Official Transcript of Proceedings
NUCLEAR REGULATORY COMMISSION

Title: Advisory Committee on Reactor Safeguards
US-APWR Subcommittee

Date: March 22-23 2012

7 US-APWR SUBCOMMITTEE

9.1.3 Spent Fuel Pit Cooling and Purification System (SFPCS)

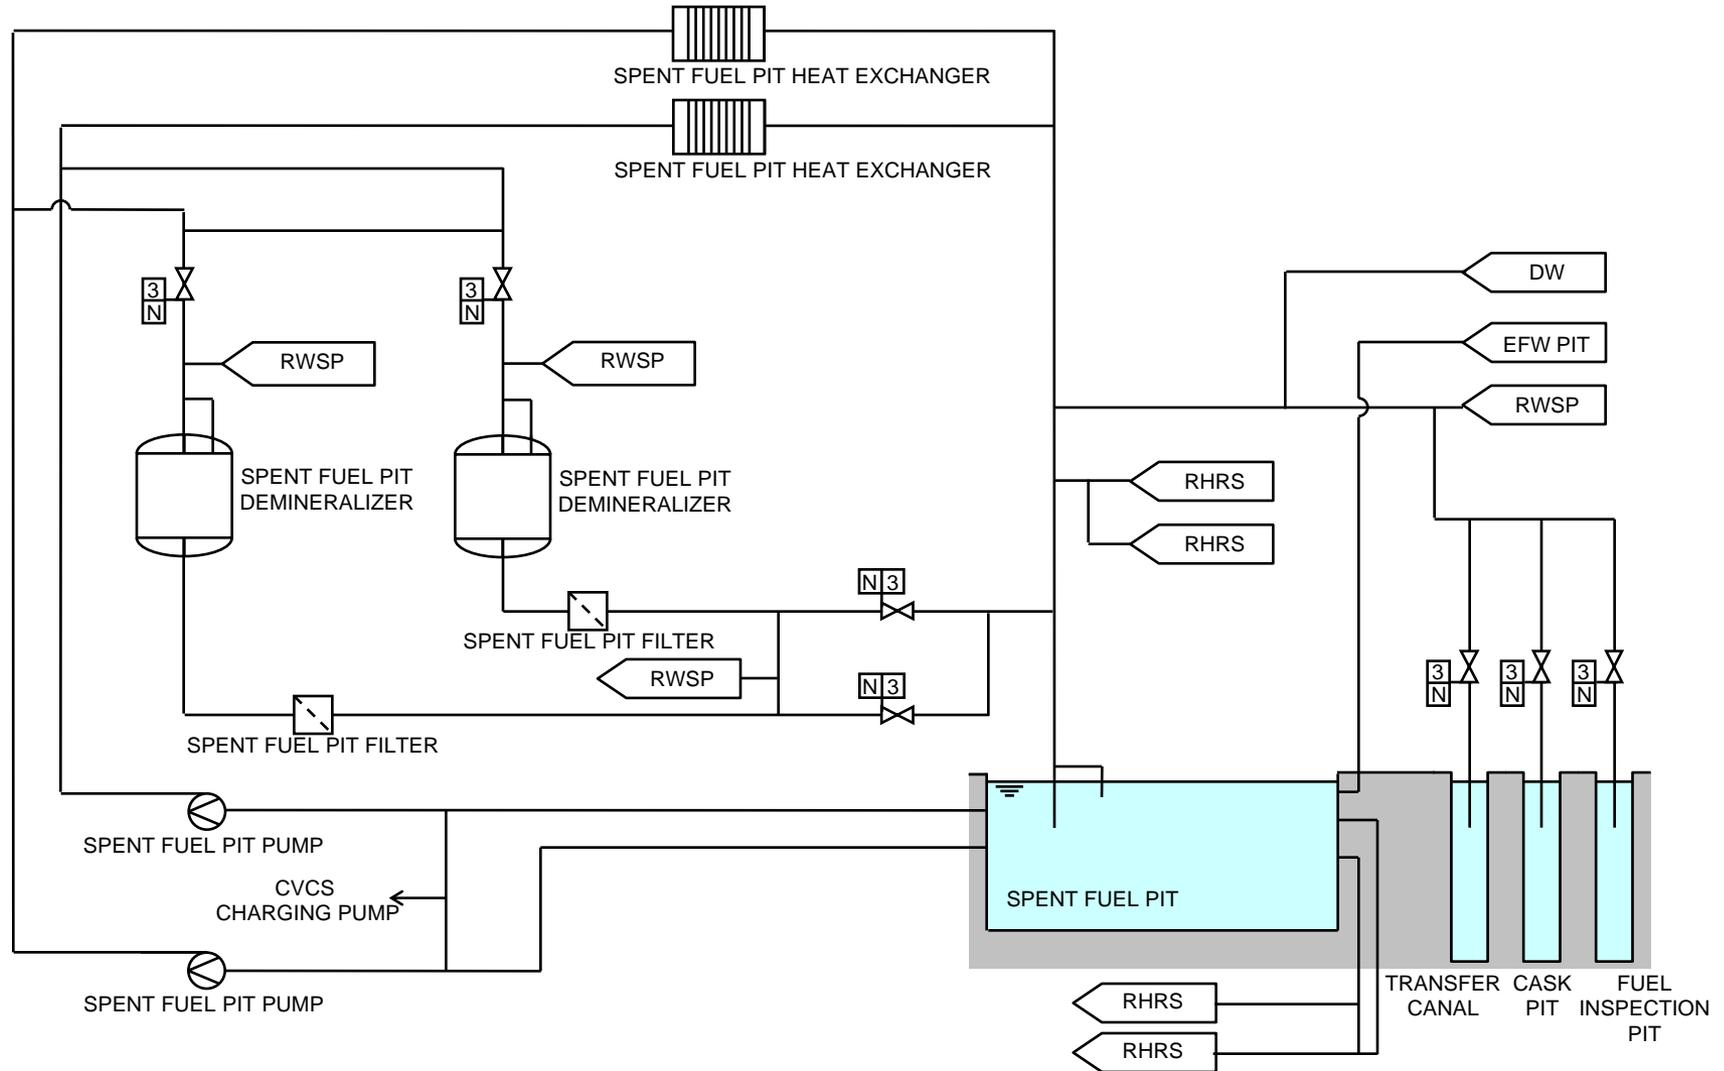
17 The containment spray RHR cooling line
18 suction elevations on that drawing are shown lower
19 than the spent fuel pit cooling suction lines at a
20 lower elevation. I didn't know whether that's
21 actually the case or whether it's just the way to show
22 both suction lines on the same drawing if they are at
23 the same elevation.

24 My question is are the containment spray
25 RHR suction lines located at the same elevation as the

1 spent fuel pit suction lines? I found a lot of
2 information in the DCD about the elevation of the
3 spent fuel pit suction lines. It may just be an
4 artifact of the way that drawing was put together to
5 show the two of them.

13 CHAIR STETKAR: That's interesting because
14 that still makes my question relevant. The spent fuel
15 pit demineralizers, as is shown on this drawing, can
16 be aligned for cleanup of the refueling water storage
17 pit. The line is coming in at the top. You go
18 through the demineralizer and go back out to the
19 refueling water storage pit recirculation pump --
20 pumps, plural.

2 The drawing you reflect, if you take the
3 one out of the DCD, gave the impression that there
4 were two level sensors but only one temperature
5 sensor. There's only one little stalk in there.
6 There's two things off of it but I don't know what --
7 I don't know the convention for that particular symbol
8 as to how many they are.

9 The second question associated with that
10 relative to temperature is if you've only got one and
11 it's only in one place, how do you know that's
12 representative of the overall bulk temperature in the
13 spent fuel pool? I often try to look at the flow
14 rates and I couldn't tell what the flow rates were.
15 There were numbers like 200 or 300 GPM and then I saw
16 the pumps were for 3,000 GPM or some large number like
17 that.

9.2.2 Component Cooling Water System (CCWS)

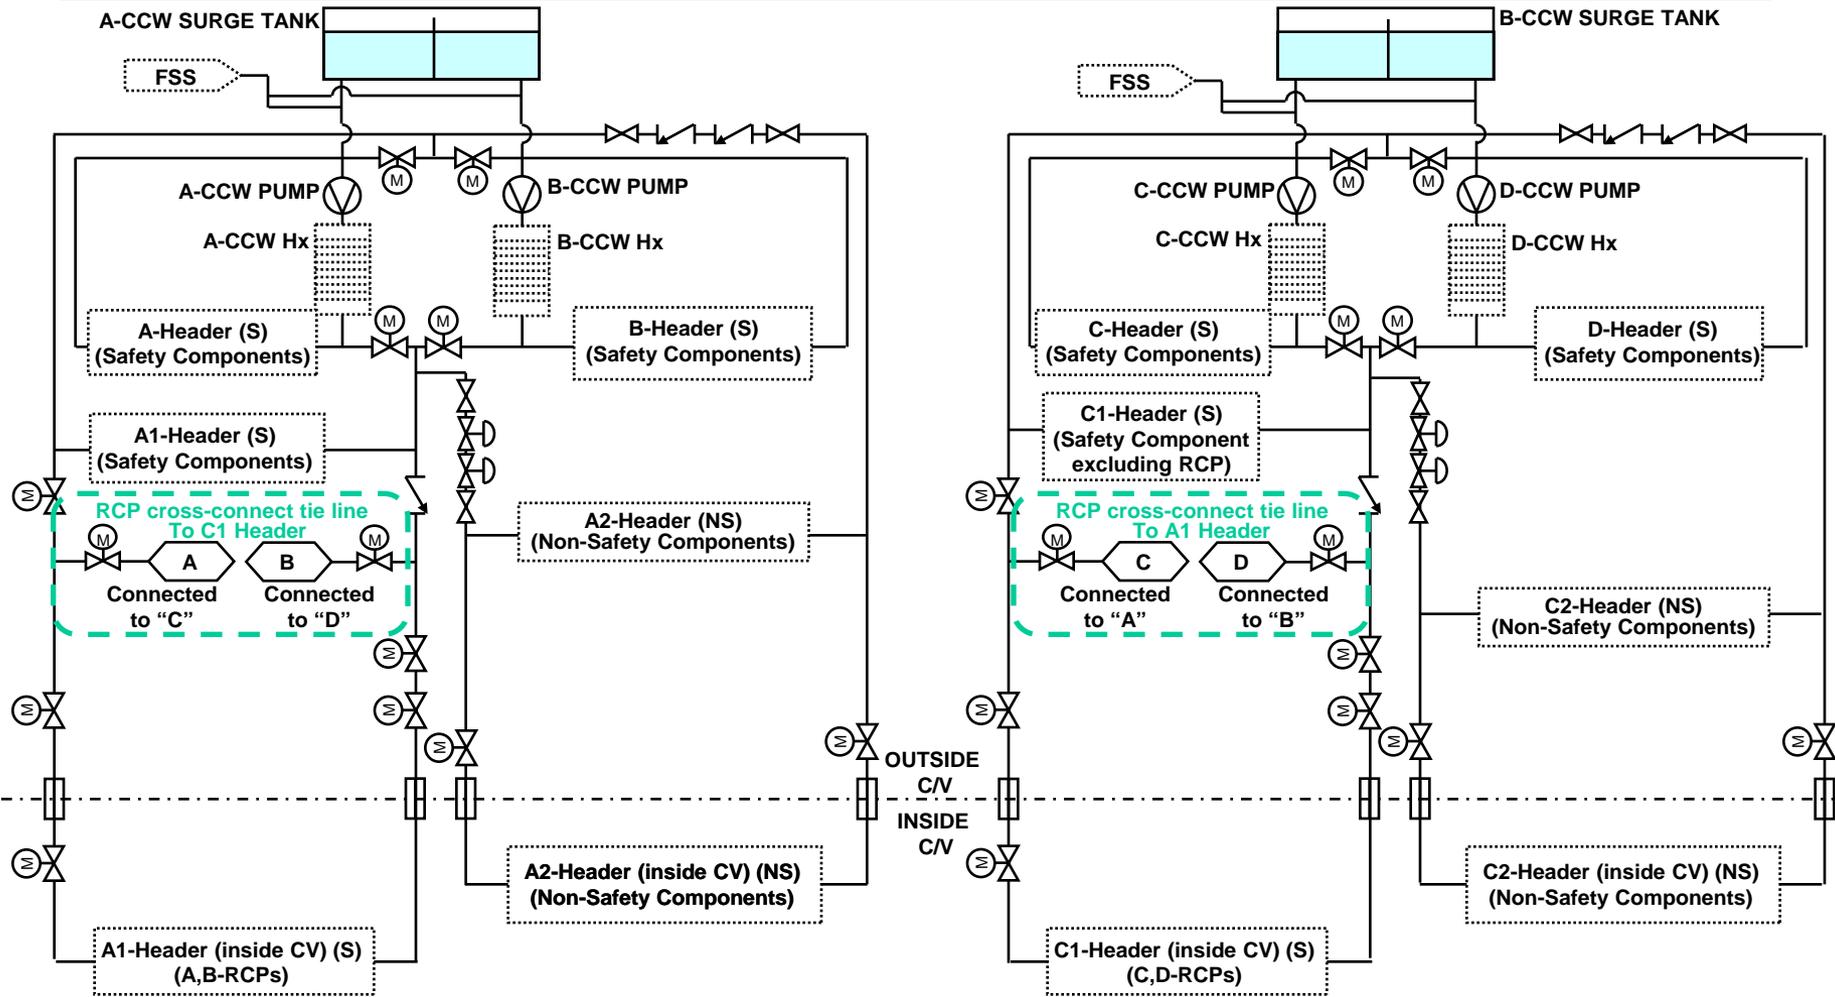
4 Just looking on Sheet 5 I could -- the
5 concern I originally had is looking at Sheet 5 if I
6 broke the piping on the drawing that you have here in
7 front of me, I could only find one isolation valve to
8 isolate the CCW header from that break.

18 Now, what I -- because I was looking at
19 drawings I didn't quite understand the second part
20 because this -- is the piping that's shown on this
21 drawing seismically qualified? If it is, where is it
22 seismically qualified? Because the way to supply
23 component cooling water now to the fan coolers, that
24 connection is shown on Sheet 5 of 9.2.2-1.

7 Now, given the fact that I'm slowly
8 starting to understand these interconnections, my
9 question now is the two locked closed valves that are
10 mentioned in the SER, are those the two normally
11 closed motor-operated valves that appear on Figure
12 9.2.2-1, Sheet 5, of the DCD in the lower left-hand
13 corner?

23 9.2.2-1, Sheet 6 is between safety and
24 non-safety. The valve is double isolation. The
25 other, Chapter 5, is a connection between CCW to the

9.4.3 Auxiliary Building Ventilation System

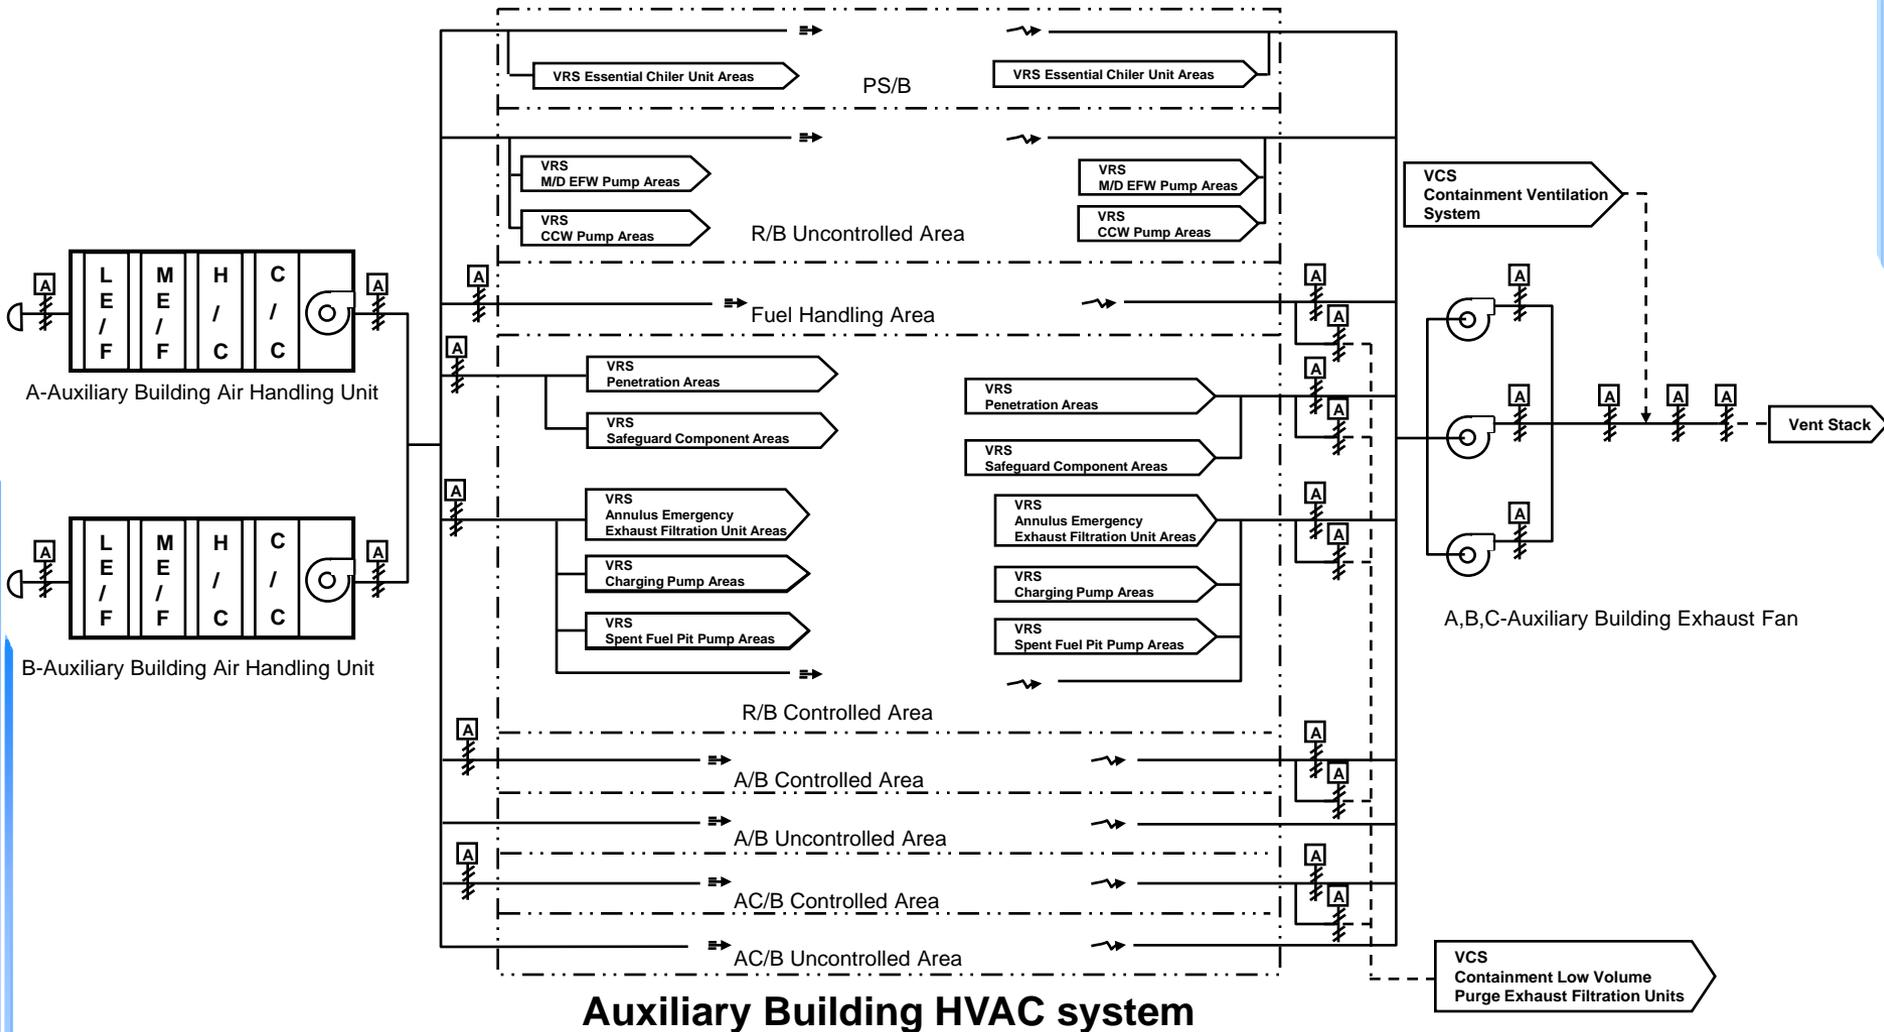
RAI No.	Question 09.04.03-X	RAI Topic / NRC Concern	RAI Response / DCD Impact
831-6030	21	<p><u>Open Item 09.04.03-21</u></p> <p>Revise DCD Figure 9.4.3-1 (ABVS) to reflect the existence of backdraft dampers.</p>	<p>➤MHI provided:</p> <p>✓DCD Subsection 9.4.3.2.1 system description will be revised to describe the backdraft dampers. The description is broadly applicable and inclusive of auxiliary building HVAC system branch ducts supplying or exhausting uncontrolled areas that may not be shown on the simplified flow diagram. Therefore, it is not practical or necessary to show the backdraft dampers on DCD Figure 9.4.3-1.</p>
